MEMORANDUM

RE: Select Beach Observations August 10, 2026

This memorandum is in response to Lisa Batchelor's request to perform select beach observations. Lee County staff had reported that there was erosion occurring at several locations, with some reference to the two (2) terminal groins. For purposes of this observation, the conditions at Redfish Pass groin, Blind Pass groin, and Jensen's Resort were observed. The conditions are described in the following sections.

Figure 3. West view of the Redfish Pass Groin with lower crest elevations identified.

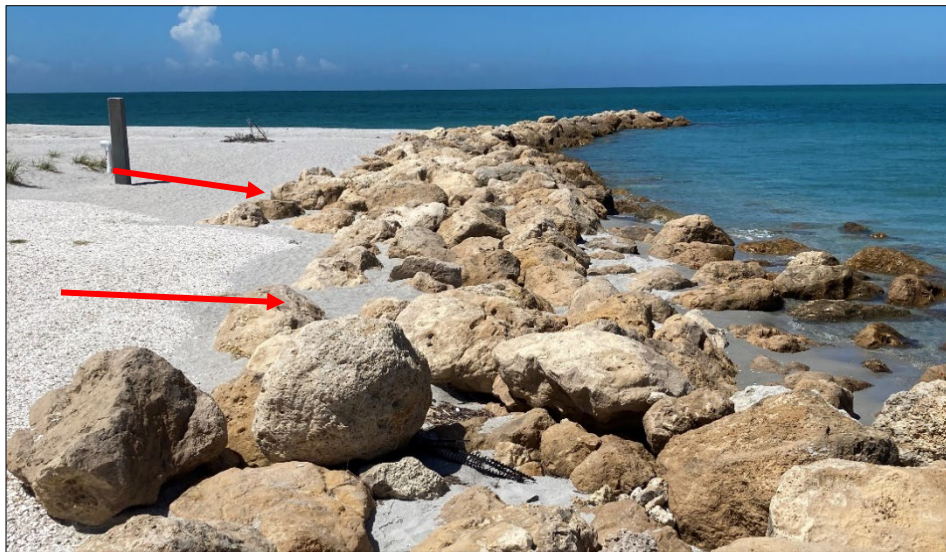
Observations of the landward end of the groin indicate that the crest of the structure is still above the elevation of the beach berm, with two small, localized depressions (small) at the landward end (Figures 3 and 4).

It is recommended that a topographic survey of the exposed portions of the structure be completed concurrent with the annual beach monitoring survey. Comparison to any as-built surveys and/or design plans should be performed to quantify structural changes.

Figure 5. West view of the head of the groin at Redfish Pass.

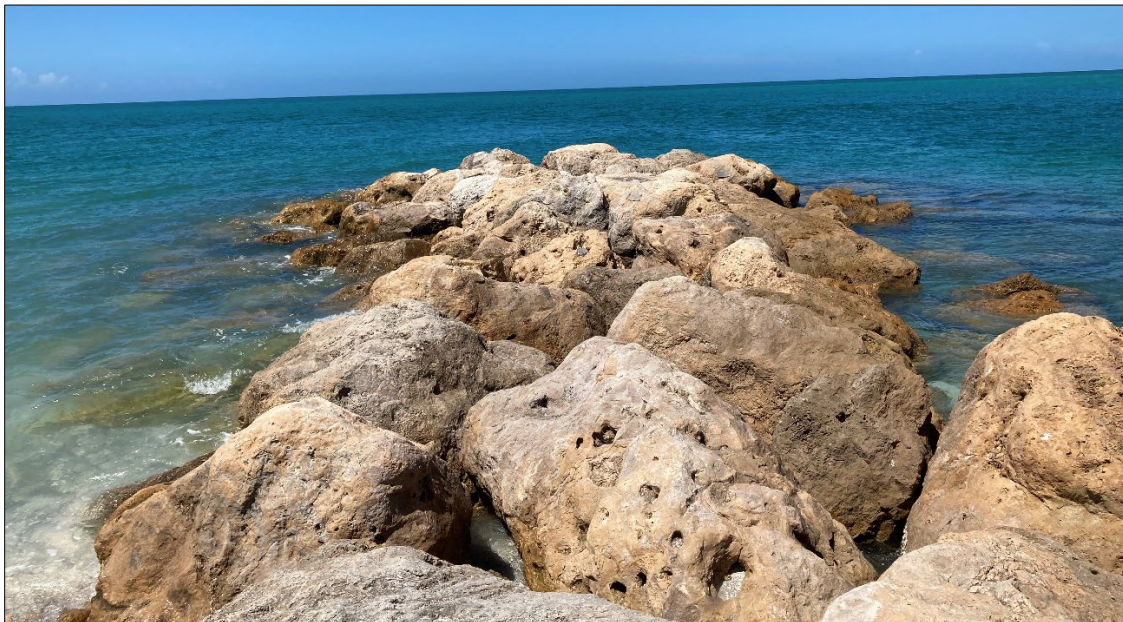
The seaward end of the structure remains a compact pile of interlocked stones, with the dimensions of the head of the structure (above the water) similar to the as-built widths. The end of the structure was constructed with flatter side slopes such that the footprint of the head of the structure is wider than the remainder of the structure (Figure 5).
